# Technical/Regulatory Guidelines

## Technical and Regulatory Guidance for Using Polyethylene Diffusion Bag Samplers to Monitor Volatile Organic Compounds in Groundwater

February 2004

## **Response to Technical Comments**

**Figure 1-2. (right) Comparison of diffusion and pumped samples in groundwater showing relative uniformity in vertical distribution of trichloroethene concentrations in the screened interval of a well (modified from Vroblesky et al. 2003).**

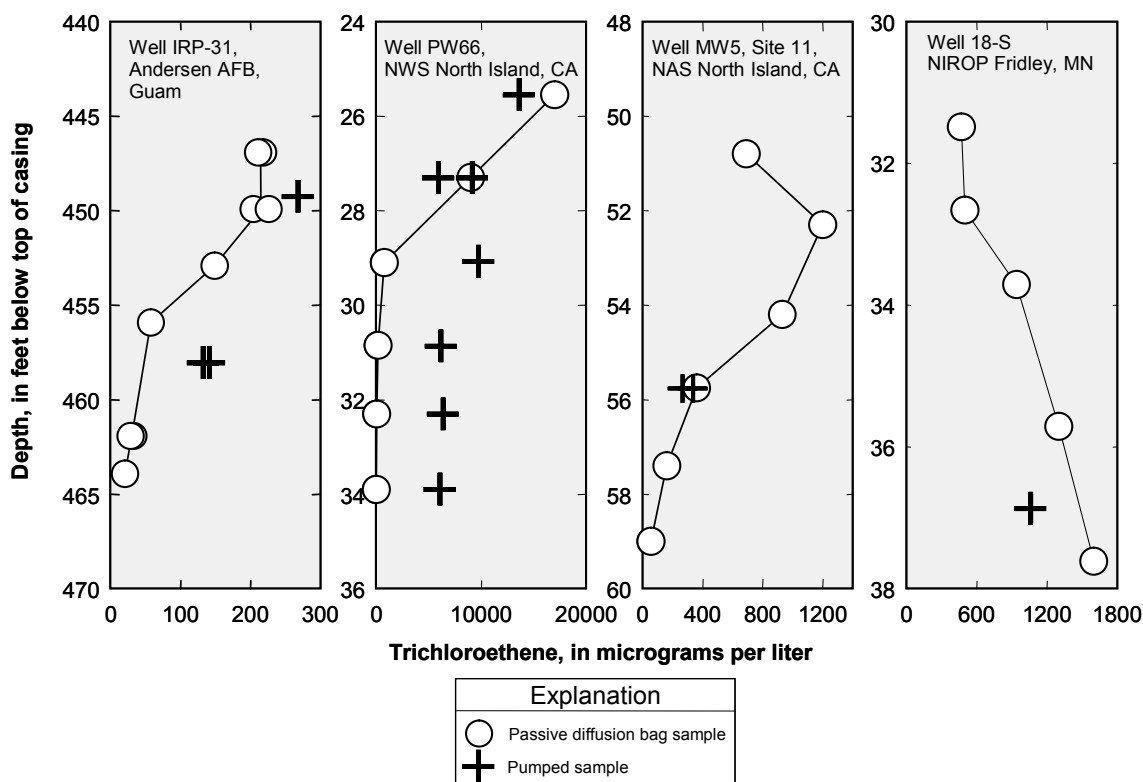
10. P.11, L.11-16: The intent of the discussion regarding Figure 1-2 is not apparent. Either the last sentence should be omitted or the thought process behind the last statement should be clearly presented. As it stands, the discussion provides two possibilities to explain the data in Figure 1-2, then dismisses the second possibility without explanation.

21. Figure 1-2: Statement “The pump produces a mixture of contaminated and uncontaminated water.” This statement also be included in Figure 1-3. While it is true that more of an averaged value is obtained with pumps, this effect is less with PDBs although they don’t seal off a specific zone within a screened interval, particularly in a 4-inch well (PDB diameter is 1.25 inches).

68. Page 3, Figure 1-2: The conclusion(s) that should be drawn from this figure is/are not clear to me. I suggest redrawing it, omitting one of the two curves included, or omitting the entire figure. Simply including a reference to the statement that “contamination stratification has been observed” may suffice.

**Figure 4-1. Regulator responses regarding the use of PDBs for various purposes.**  
(The 54 responses came from 23 different states.)

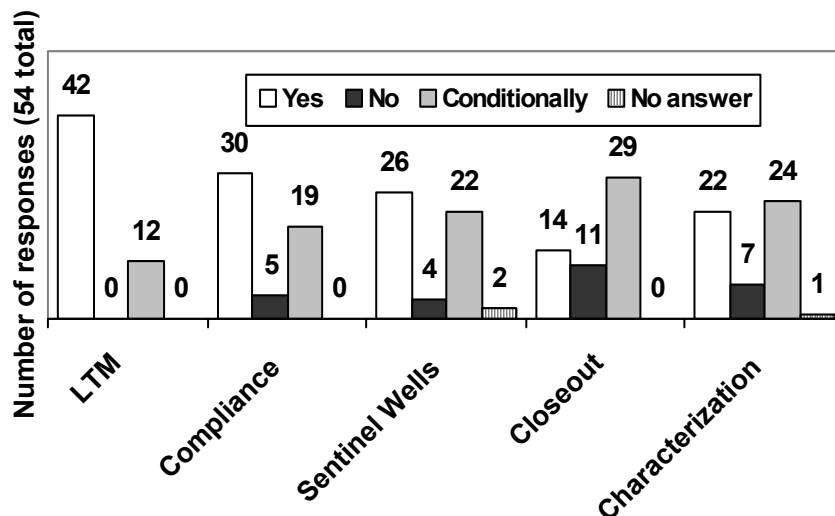
36. Page 36, Line 6: The question asked to be paraphrased and not quoted. Where is the reference to Figure 4-1? Figure 4-1 on page 37 should follow this section on page 36.

**This paragraph has been modified and reference to the figures clarified.**

**Figure 4-2. PDB survey results from 23 states indicating regulator support for specific uses of PDBs.**  
(Note that the responses reflect not an official state policy but only the proclivity of individual regulators.)

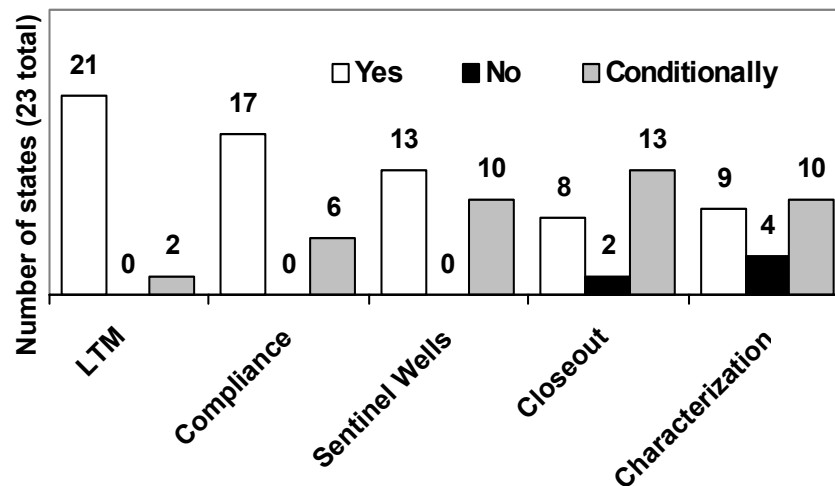
37. Page 38, Lines 5-7 and Figure 4-2: It is misrepresenting the states’ responses to include only one positive response to closeout while a majority may have rejected it.

38. Figure 4-2 Caption: Too many prepositions. Reword “PDB survey results from 23 states indicting regulators acceptability to specific uses. . . .”

**There is no best way to condense multiple responses from a given state. The approach taken—to display the response most favorable to PDB sampling—is not a misrepresentation but one alternative that was clearly presented as such. The reader is free to consult the data in Appendix D to conduct his own analysis. The caption for Figure 4-2 has been modified to call attention to the assumptions stated in the text.**
